Office Action Summary

10/035,829

NOVOTNY ET AL.

- 1) ☒ Responsive to communication(s) filed on 07 October 2004.
- 2a) ☒ This action is **FINAL**. 2b) ☐ This action is non-final.
- 3) ☐ Since this application is in condition for allowance except for formal matters, prosecution as to the merits is closed in accordance with the practice under *Ex parte Quayle*, 1935 C.D. 11, 453 O.G. 213.

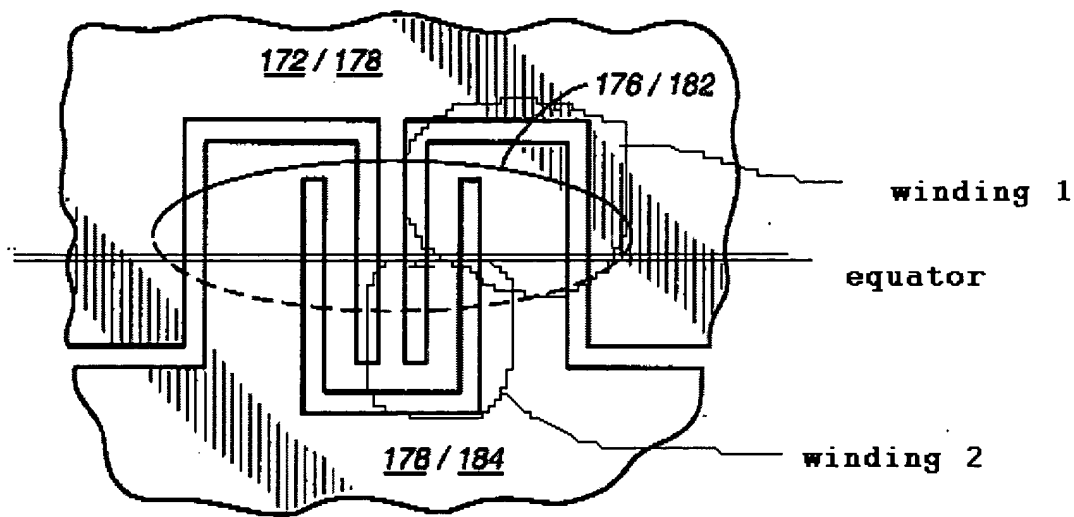
Claim 25: The Neukermans apparatus modified by the teaching of McClelland as discussed above with regard to claim 16 meets the limitations of claim 25. It is noted that each winding of the serpentine hinges gets progressively shorter from the optical element end to the support structure end. See the annotated fig. 14 below:

It is evident that winding 2 is shorter than winding 1, at least by virtue of the fact that its turn-around or switchback section is shorter than that of winding 1.
